## **Core Bus Corridor 14: UCD - Preliminary Submission**

Dublin Cycling Campaign is a registered charity that advocates for better cycling conditions in Dublin. Dublin Cycling Campaign is the leading member of Cyclist.ie, the Irish Cycling Advocacy Network (ICAN). We want to make Dublin a safe and friendly place for everyone of all ages to cycle.

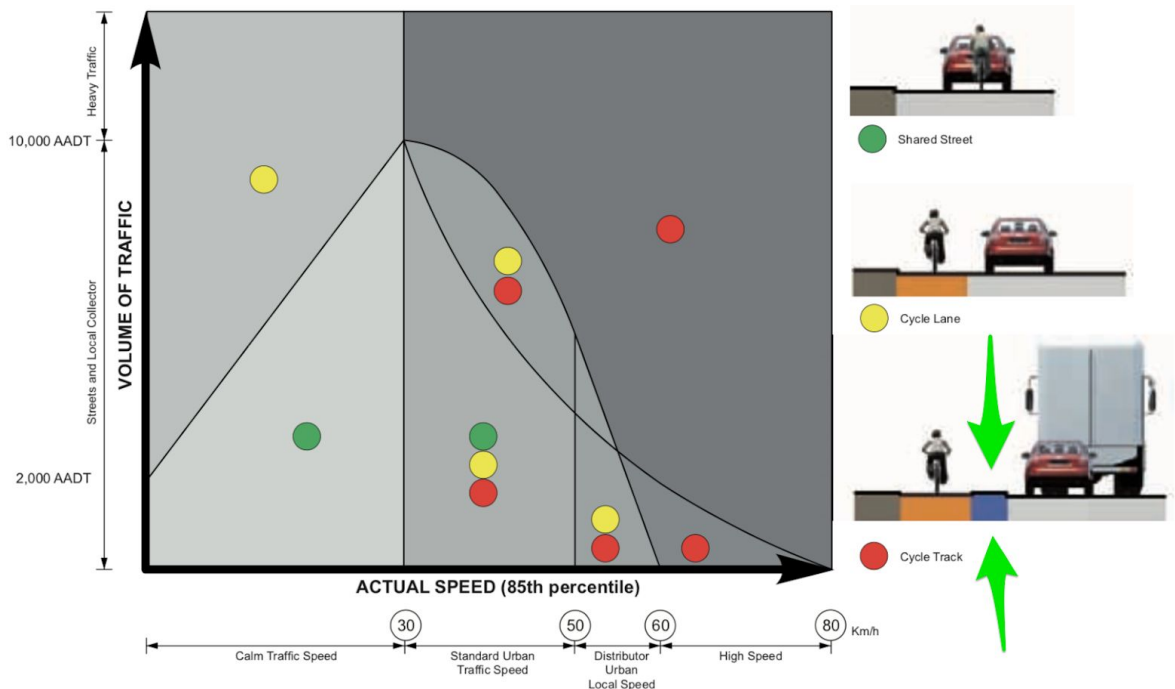
Unfortunately, the cycle track is never wider than 2 m on this CBC and there are some locations where it is even narrower than this. On Pembroke Road, the cycle track will be just 1.5 m in places. On parts of Merrion Road (maps 8 & 9), the cycle track appears to be even narrower, but no dimensions are provided. On Baggot Street bridge and on Merrion Road near Nutley Lane (map 9), no cycling infrastructure will be provided at all.

More effort should be made to eliminate these pinch points and widen as much of the cycle track as possible to 2.5 m. Section 2.2.2 of the Design Manual for Urban Roads and Streets recommends that pedestrians and cyclists should be prioritised before motor traffic. Therefore, where there is not enough space for appropriately wide cycle tracks, removing car parking or diverting traffic should be preferred over narrowing or removing cycling infrastructure and footpaths.

*NTA proposal for Baggot Street Lower*

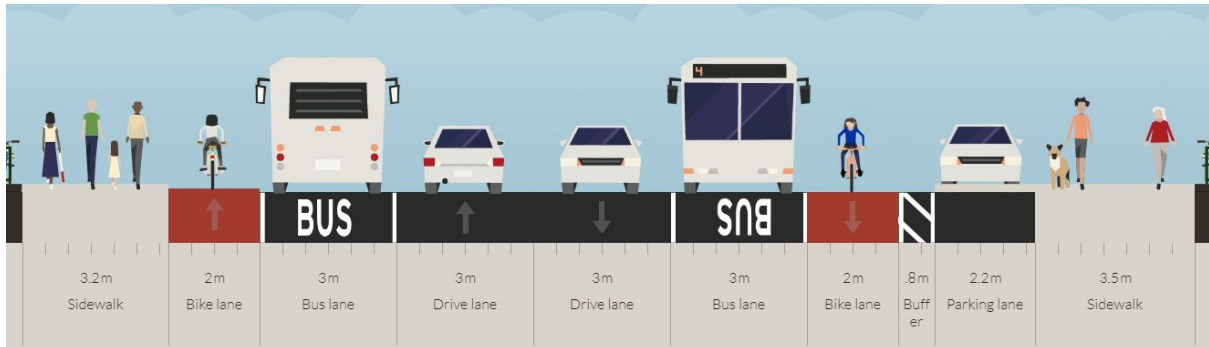
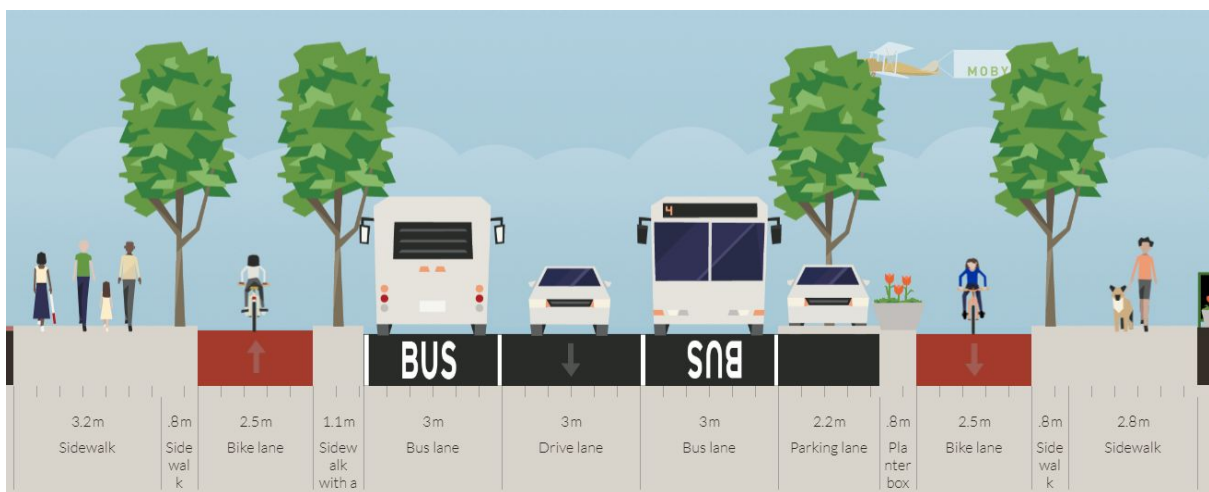
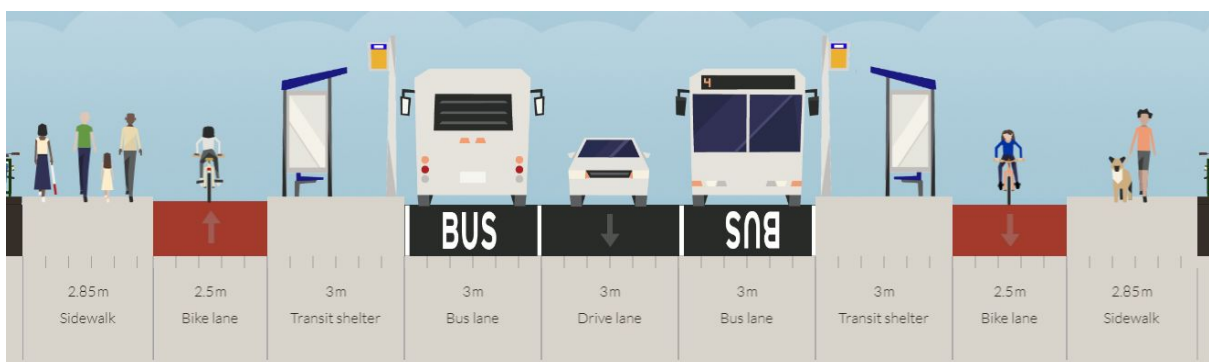
*Alternative layout for Baggot Street. The safety audit mentions that retaining the trees would be beneficial and help to keep speeds down. This option would make space for lots of trees either at the sides or down a central median.*

*This layout would easily accommodate island bus stops*

*Baggot Street Bridge, one way for private cars, no bus priority light*

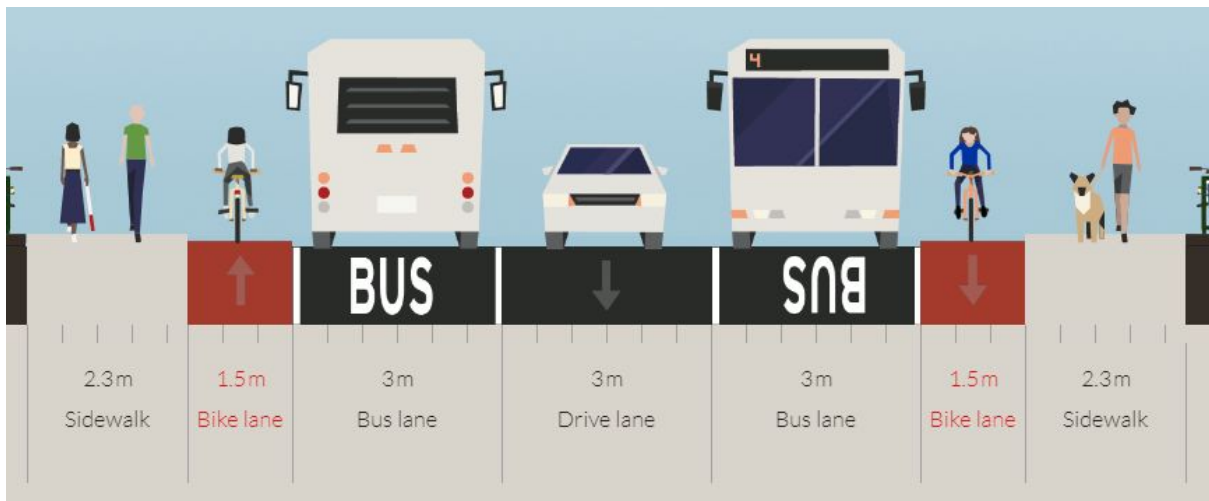
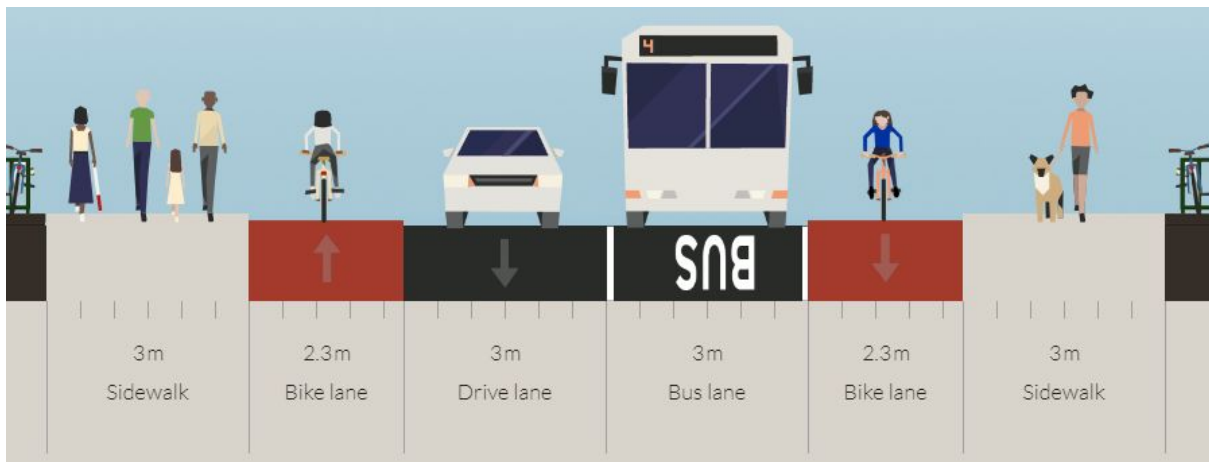
If a one way private vehicular traffic system was introduced, cycle tracks could also be installed on Baggot Street Bridge without narrowing the footpaths. With bus priority lights, the bridge could be reduced to two lanes, facilitating wider footpaths and a more appropriate width for the cycle track

*Near Mespil Road; NTA option vs alternative*

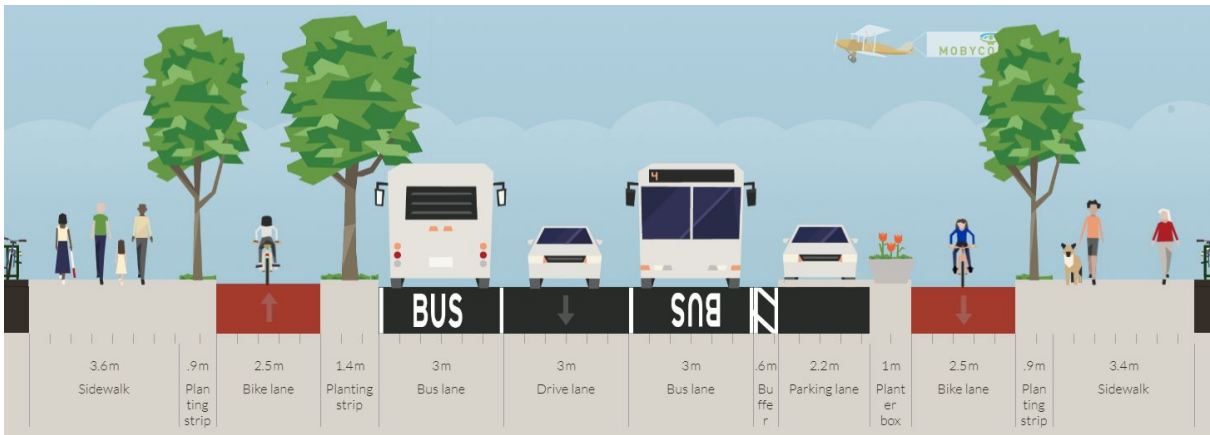
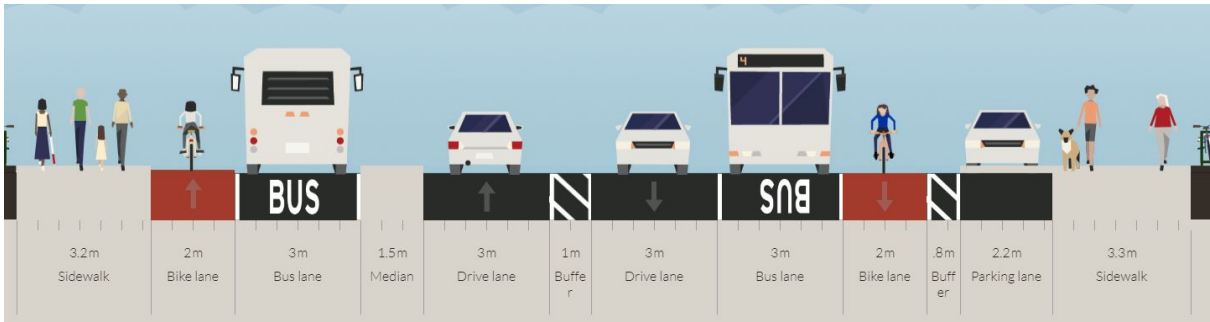
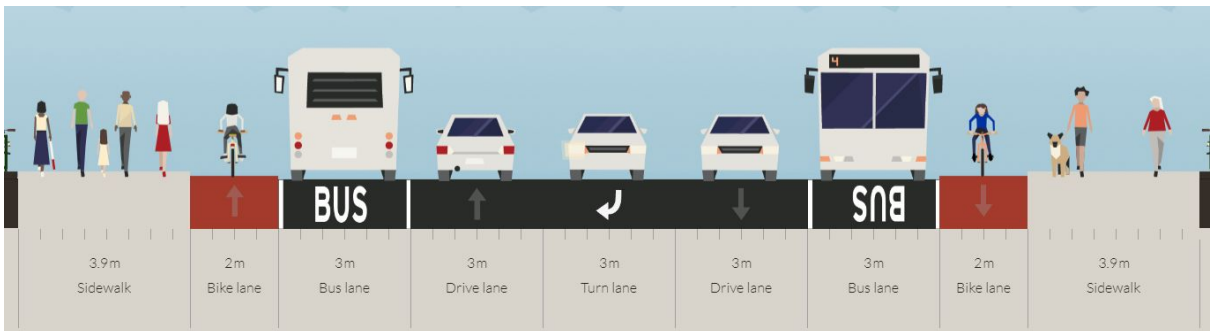
There are bus stops and a number of parking bays on this stretch of road. Reducing the number of traffic lanes would allow the cycle track to bypass these hazards.

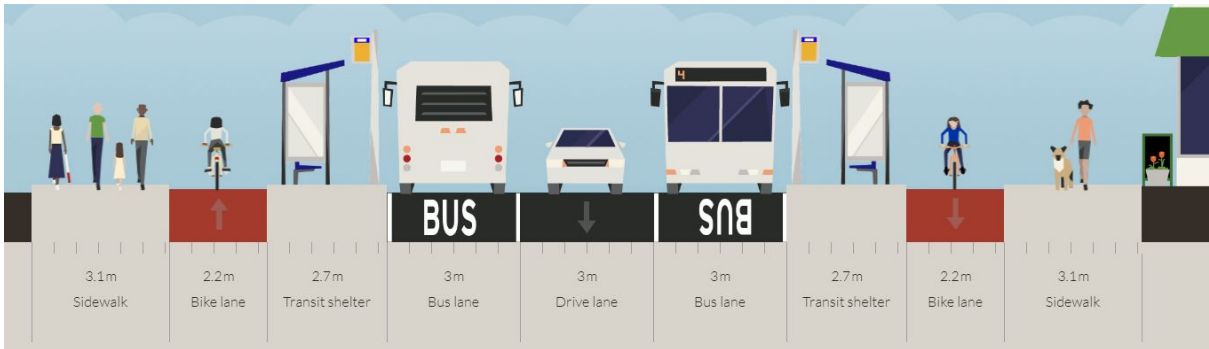
The stretch of Pembroke Road outside the Ballsbridge Hotel is in excess of 25 m wide. There is no reason that island bus stops cannot be installed here, rather than provision for an extensive designated right turning traffic lane?

We welcome the closure of the Elgin Road outlet to the main route, and the potential for improved public realm and increased pedestrian safety. But the opportunity for cyclists' access to and from Elgin Road needs to be retained and made clear, as Elgin Road and other streets in this area are important quietways for cyclists. There is also an opportunity to include a specific bike slip lane on this proposed new landscaped area.

*Simmonscourt Road bus stops could look like this*

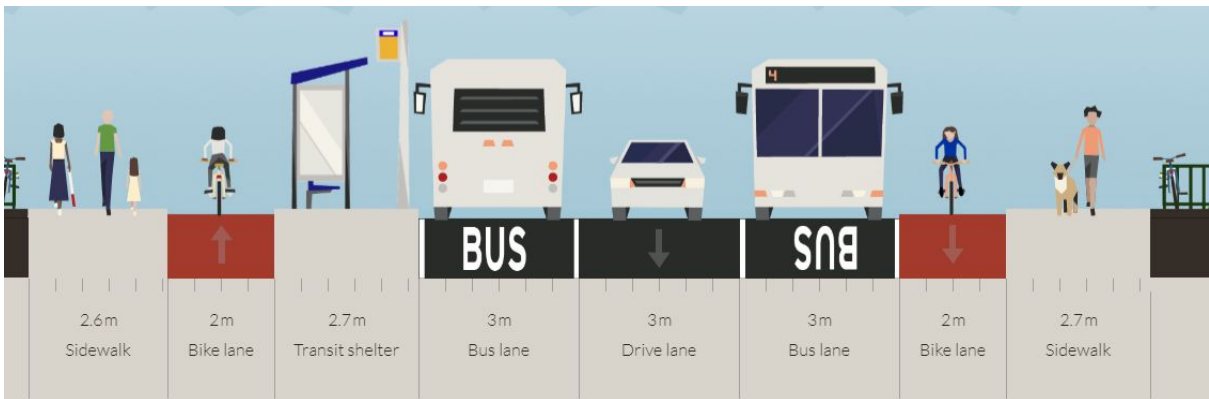
At the Simmonscourt Road junction, which is 400 m from the RDS bus stops, Merrion Road is about 21 m wide. Therefore, without removing any trees, an island bus stop could be provided on each side of Simmonscourt Road.

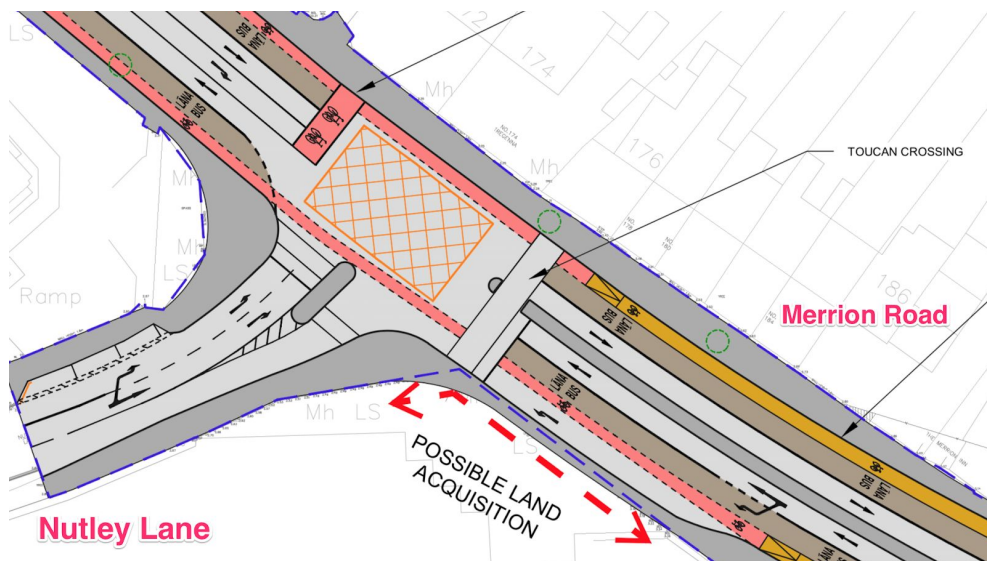
The Merrion Road/Nutley Lane junction does not allow right turns to be safely made by cyclists. Buses on Nutley Lane will all be turning left, making the right turn for cyclists dangerous. It is not clear where cyclists wishing to turn right from Merrion Road onto Nutley Lane are expected to wait. The previous public consultation and the feasibility designs from AECOM for this junction included continuous dedicated cycle lanes through the junction.

*Extract of CBC14: UCD public consultation document showing loss of the outbound dedicated cycle facility in order to make space for a bus priority light*

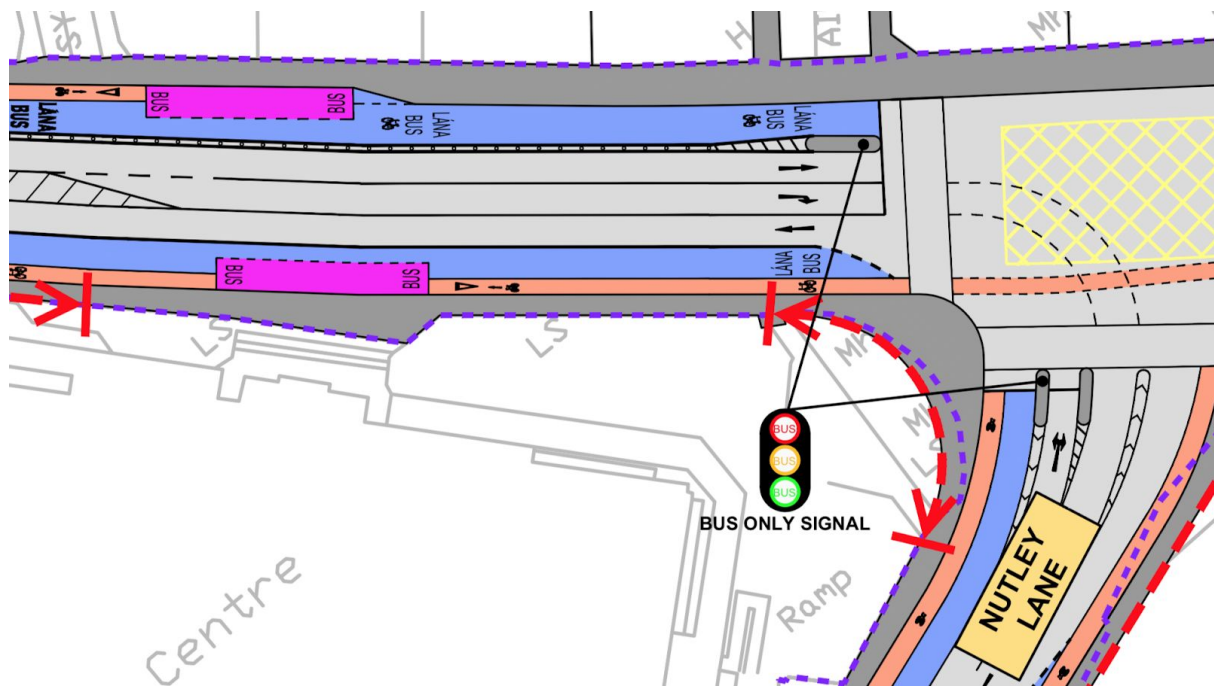
These dedicated cycle facilities have been compromised for a traffic island for bus priority lights. We understand the need for bus priority lights for right turning buses, however, it must not come at the cost of dedicated cycle facilities at this location.

*Possible improvements for cyclists on the outbound side of the road*

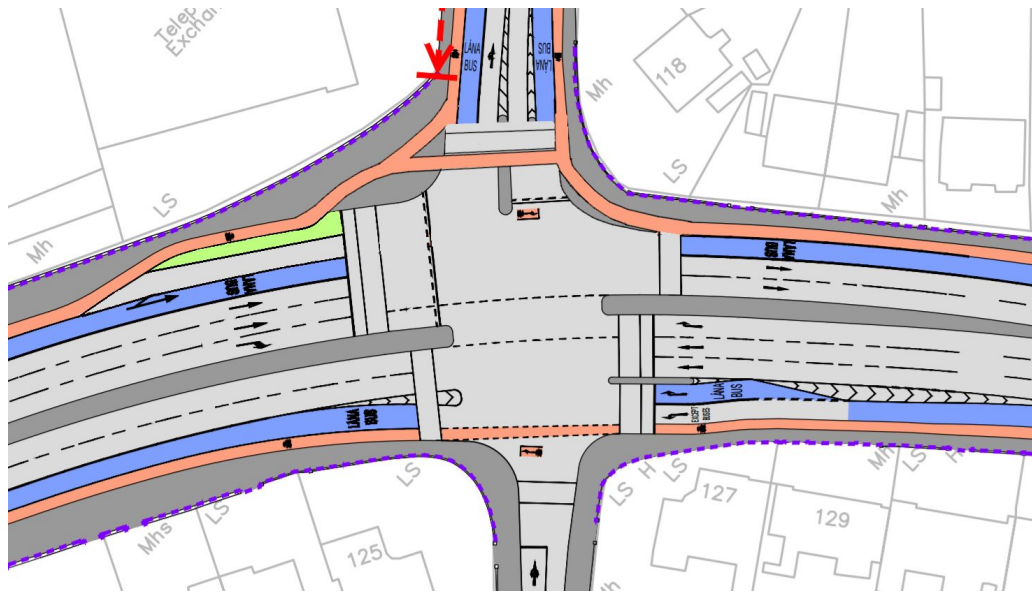
The Stillorgan Road/Greenfield Park Junction (map 12) includes a dedicated left-turn traffic lane with a cycle track outside, on the inward Stillorgan Road.. This junction is the location of a recent cycling fatality caused by a left-turning truck. More should be done here to reduce the likelihood of left-hook collisions such as providing a kerb-protected lozenge island or an advanced stop line for cyclists.

The junction design overall needs to be upgraded to give clarity for cyclists making right turns in particular, but also to bring cycle tracks through the junction. Greenfield Park is also an access route to and from UCD.

*Extract of map 15*

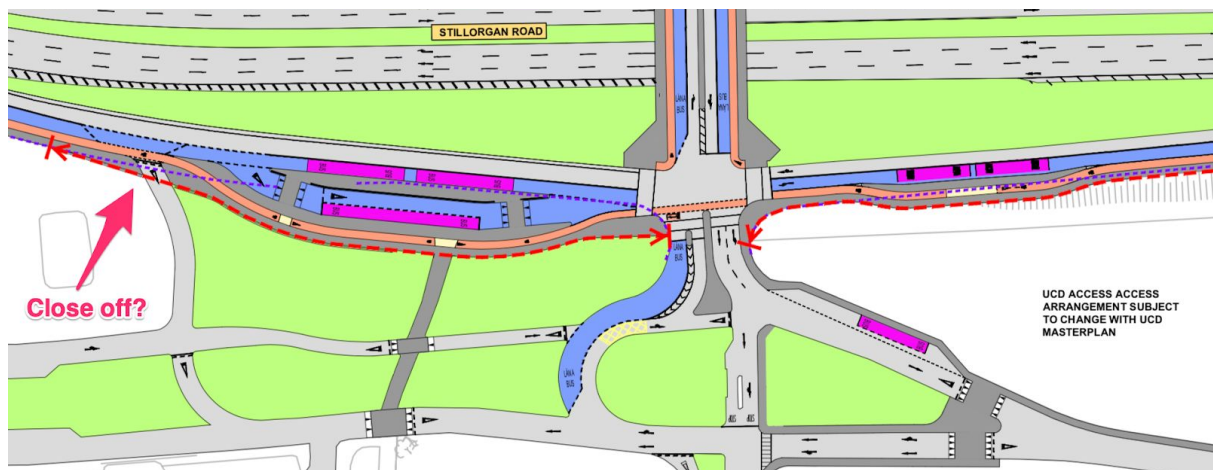
We welcome the significant improvements to the bus stops at this junction, but the junction designs can be improved further.

1. The cycle tracks on the flyover should continue into the junction and be more direct, rather than merging into shared space. Shared space is dangerous for cyclists and pedestrians, and there is more than enough space to avoid using it here.
2. Ideally, the UCD exit lane to the north of the flyover should be closed off to motor traffic. This would remove a conflict point between cyclists and motor vehicles and provide an intuitive route for cyclists to exit UCD and join the inbound cycle track
